**PROPOSED MUIZENBERG BEACHFRONT REFURBISHMENT (DBAR COMMENTS – 04 MAY 2023)**

**Comments from interested and affected parties**

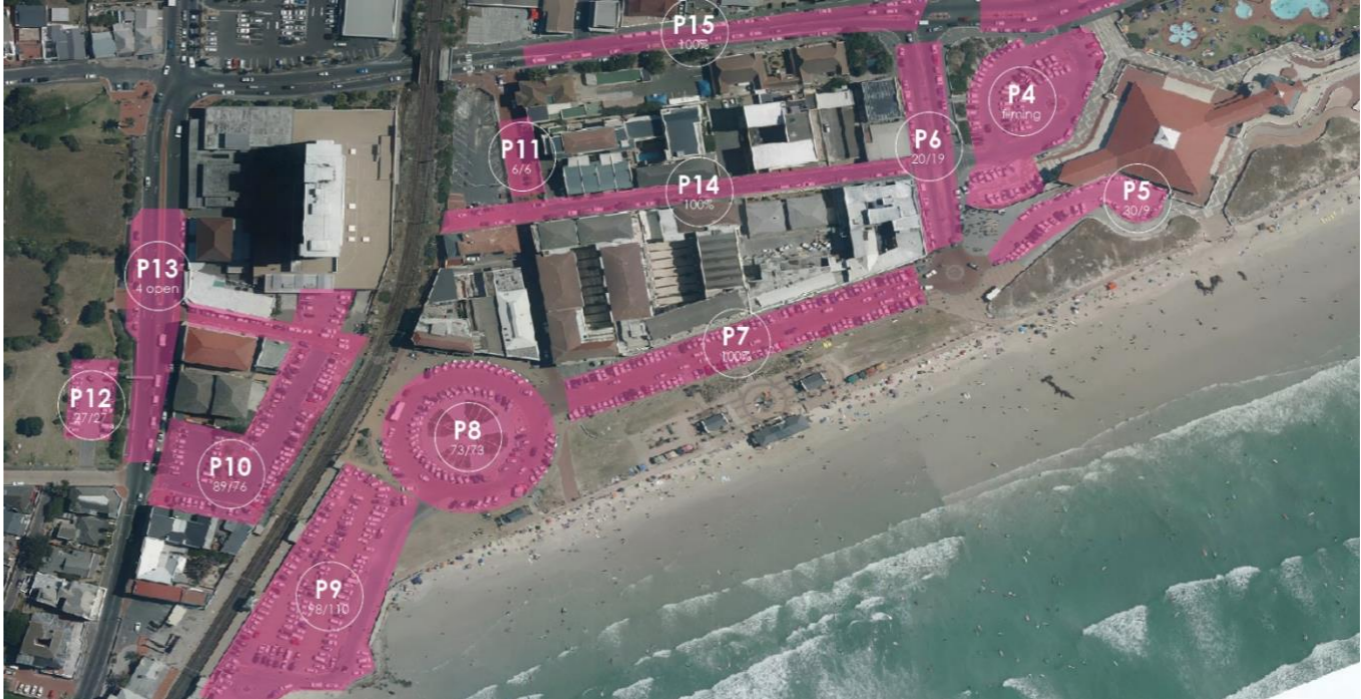
Comment by	Date Received	Comment	Response
			 <p>Figure 7: : Impact on sea view along beachfront shops (picture taken from Kauai entrance)</p>
<p>Karen Tulloch (Property Appeal)</p>		<p>To whom it may concern <b>RE: Surfers Corner, Muizenberg beachfront refurbishment – location of the abluition facilities on the beach front</b></p> <p>As the Property Manager for Property Appeal (Pty) Ltd, we represent Property Appeal (Pty) Ltd who are the registered owners of 10 ground floor sections in the Muizenberg Body Corporate. We wish to formally express concern and lodge an objection towards the abluition facilities (item 3) being situated in front of the retail shops.</p> <p>The abluition facility will block the sea view of the coffee shops and restaurant situated on the ground floor. This may have a negative effect on the number of patrons visiting the coffee shops and restaurants, and the sea view is currently a major attraction. A further concern in the loss in revenue</p>	<p>Thank you for the comment, the concern is noted. Kindly consider the response below.</p> <p>Please note the final location of the abluition facility was determined from the public input based on options put forward earlier in the public consultation process.</p> <p>Since the views in the centre of the beachfront are already compromised by the existing abluition building, bathing boxes and the two NGO buildings (NGO buildings remain in place), setting back of the abluition facility will have minimal impact on the total sea view of the ground floor retail shops. The eight beach huts, currently on either side of the NGO buildings, will be clustered and positioned seaward of the proposed abluition as indicated on the plans, this will visually open up the rest of the beachfront to the sea. There will be a net increase in total sea view along the beachfront shops. Figure 8 below illustrates this point. From the observation point of this photograph, only two narrow view corridors between the existing abluition and the NGO buildings will be reduced (extent depends on observation point) and two large view corridors at the sides will be open. When observing from shops on either side of the image below, albeit reduced in width, the view between the abluition and NGO buildings remains, but also gains the wider views on either side of the NGO buildings.</p>

Comment by	Date Received	Comment	Response
		<p>due to patrons not wishing to visit the coffee shops and restaurants anymore.</p> <p>Kindly consider this matter.</p>	<p>In order to provide the required additional universal access toilets and family change rooms and to fit into the available space, whilst allowing for planters and existing size walks, the width of the proposed ablution is 3.7m wider and 2.7m narrower than the existing (when including the width of two small canopy structures on side of existing ablution, the proposed and existing are equal width). Although similar in size, it is acknowledged that due to the effect of perspective, it may be perceived larger. Please also note that the building will follow the same architectural style as the existing buildings, including the roof design. The design endeavours to maintain the roof height as low as possible whilst remaining with the existing style. Please note that there will also be planters with locally indigenous plants around the building, between it and the sidewalk and parking. All building services etc. will also be hidden from sight.</p>  <p>Figure 8: Impact on sea view along beachfront shops (picture taken from Kauai entrance)</p>
